April 2018
FL760A
NHTSA #18V-116

Subject: uSTART Ultra Capacitors

**Models Affected: Specific Freightliner Custom Chassis
MT45G/55G chassis manufactured June 22, 2017, through
October 31, 2017, and equipped with uSTART Ultra Capacitors.**

Fig. 2, uStart Battery

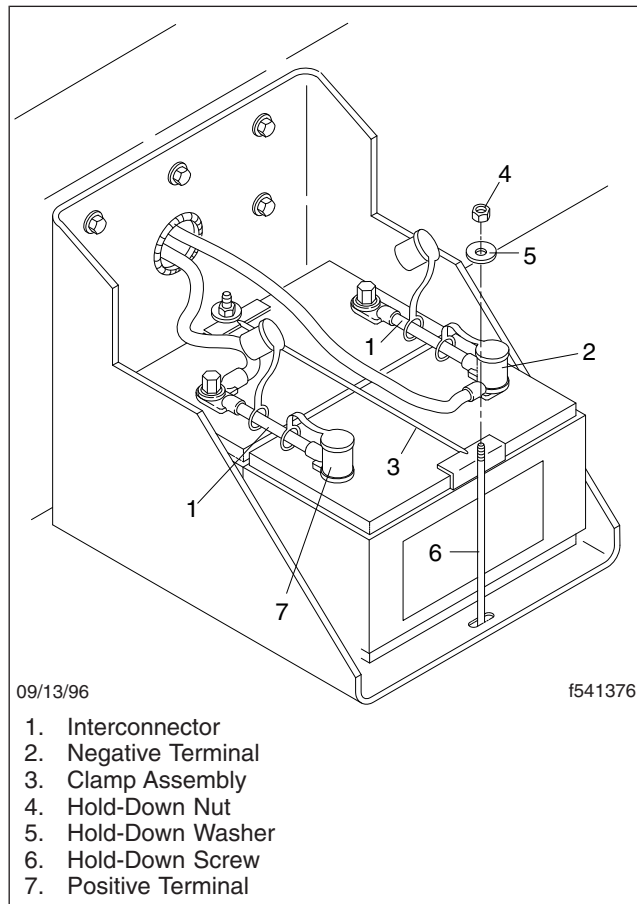
A bracket used to secure the ultra capacitor to the battery tray may cause damage to the upper surface of the capacitor and allow water to enter the capacitor. Water entering the capacitor could lead to corrosion, a short, or possible fire within the battery box.

6. Remove the battery hold-down fasteners and clamp assembly; then remove the uSTART from the battery box and set aside. See [Fig. 2](#).

The capacitor will be replaced with a conventional battery.

1. Place the battery in the carrier with the terminals in the proper position, as removed. The batteries should rest level in the carrier.
2. Install the battery clamp assembly, and tighten the hold-down fasteners to 9 to 12 lbf-ft (1224 to 1632 N-cm). See [Fig. 2](#).
3. For corrosion protection, liberally apply pumpable dielectric grease, part number 48-0239-000, to the battery terminal pads.
